Wollongong Local Planning Panel Assessment Report | 24 August 2021

WLPP No.	Item No. 4
DA No.	DA-2020/908
Proposal	Residential – Demolition of dwelling house, consolidation of lots, construction of multi dwelling housing and eight (8) lot Strata subdivision.
Property	Lot 596 DP 752033 & Lot 1 DP 1251631, 14 and 14A Laurina Avenue, HELENSBURGH NSW 2508 Lot 4 & 5 DP 706067, 11 & 13 Rajani Road Helensburgh
Applicant	Shinbo Holdings Pty Ltd
Responsible Team	Development Assessment and Certification - City Wide Planning Team (AK)

ASSESSMENT REPORT AND RECOMMENDATION

Section 5.12 Solar Access Requirements

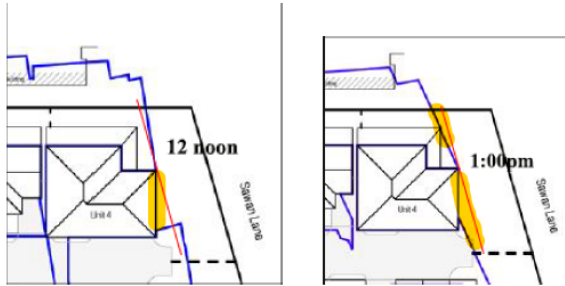
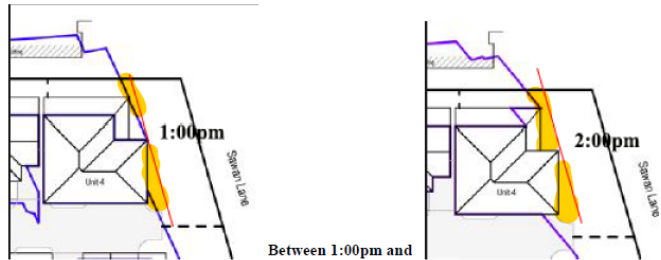
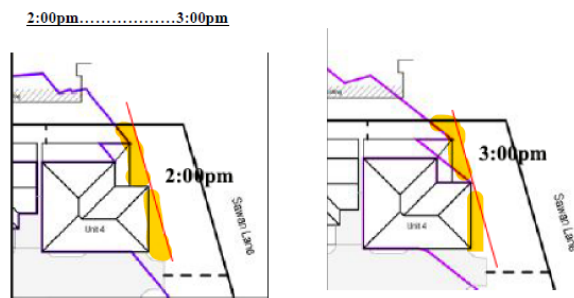
Section 5.12.2 (5) requires that at least 50% of the private open space area for each of the subject dwellings in the development must receive at least 3 hours of sunlight between 9.00am and 3.00pm on 21 June.

b) The extent of the proposed variation and the unique circumstances as to why the variation is requested;	<p>Applicant Response:</p> <p>Extent of variation to this proposal: Solar access for the relevant times during the winter solstice are summarised below:</p> <p><u>12 noon1:00pm</u></p>  <p>Between 12 noon and 1:00 pm the sun strikes the western extremity with very minimal penetration into the POS area. The surrounding landscaped area of the deep soil zone and a small portion adjacent to the garage receive full sun.</p> <p><u>1:00pm.....2:00pm</u></p>  <p>Between 1:00pm and 2:00pm the sun strikes the western extremity with 50% penetration into the POS area occurring at around 2:00pm. The surrounding landscaped area of the deep soil zone and a small portion adjacent to the garage receive full sun.</p>

Between 2:00pm and 3:00pm the sun strikes the western extremity with in excess of 50% penetration into the POS area.
The surrounding landscaped area of the deep soil zone and a small portion adjacent to the garage receive full sun.

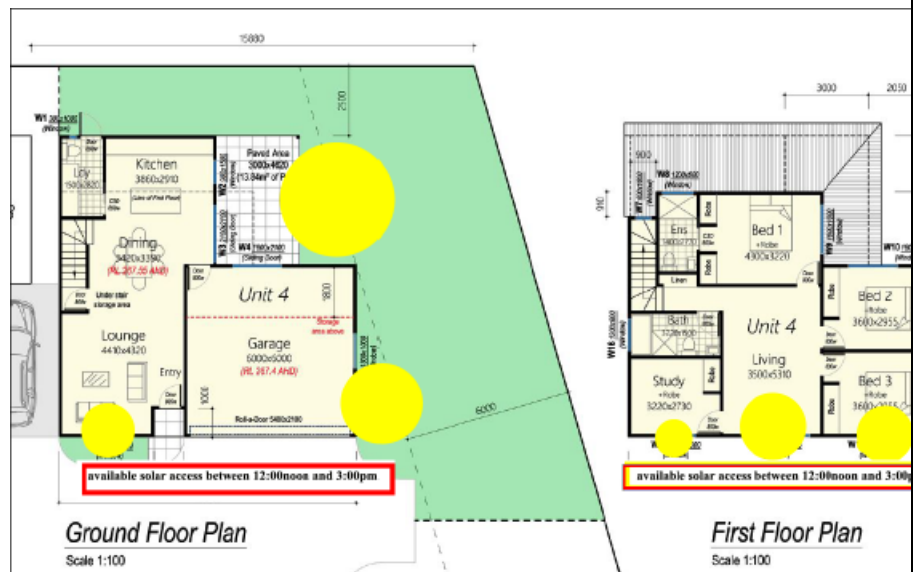
The design of unit 4 has 2 living areas and multiple rooms at level 1 (study + bed3) which will receive sunlight for the majority of the day between 9:00am and 3:00pm particularly the upper floor areas which will be above vertical cutoff angles.

Mentioned previously a small area adjacent to the garages and the landscape area surrounding the POS will receive in excess of 3 hrs as required so that at some time during the day solar access in excess of 3 hrs will be available in varying amounts depending on location internally or external to the building. (refer diagram below).

Council comment:

- The POS area for Unit 4 is considered the entire rear yard allocated to Unit 4 consistent with the proposed strata subdivision plan. As such, adequate solar access is available for

CHAPTER E6: LANDSCAPING

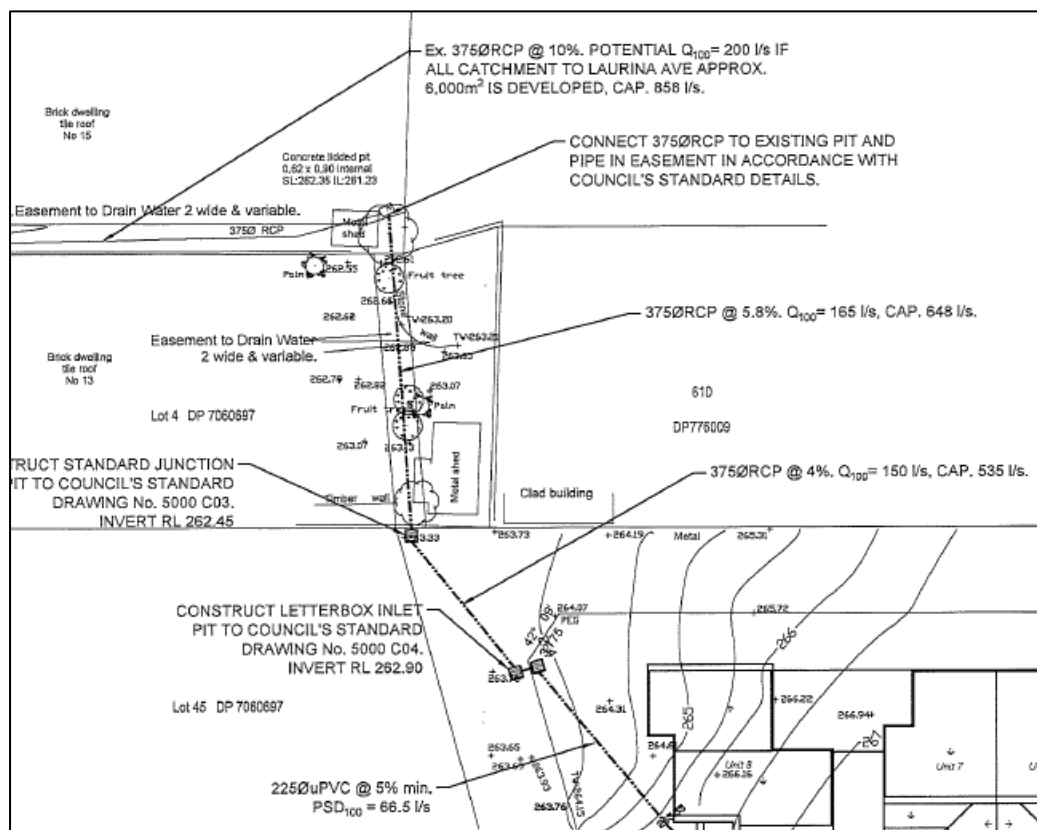
Council's Landscape Officer has reviewed the application with regard to Chapter E6 and is satisfied subject to appropriate conditions of consent which are included at Attachment 3 of the report.

Deep soil zones are provided across the rear of the site whilst plantings to the front and side setbacks have been proposed to minimise any perceived adverse visual impacts. Eight (8) trees are also proposed to the front and rear setbacks. In addition, Council's Landscape Officer has conditioned that 3 street trees are to be provided to the Laurina Avenue street frontage where frontage works are required.
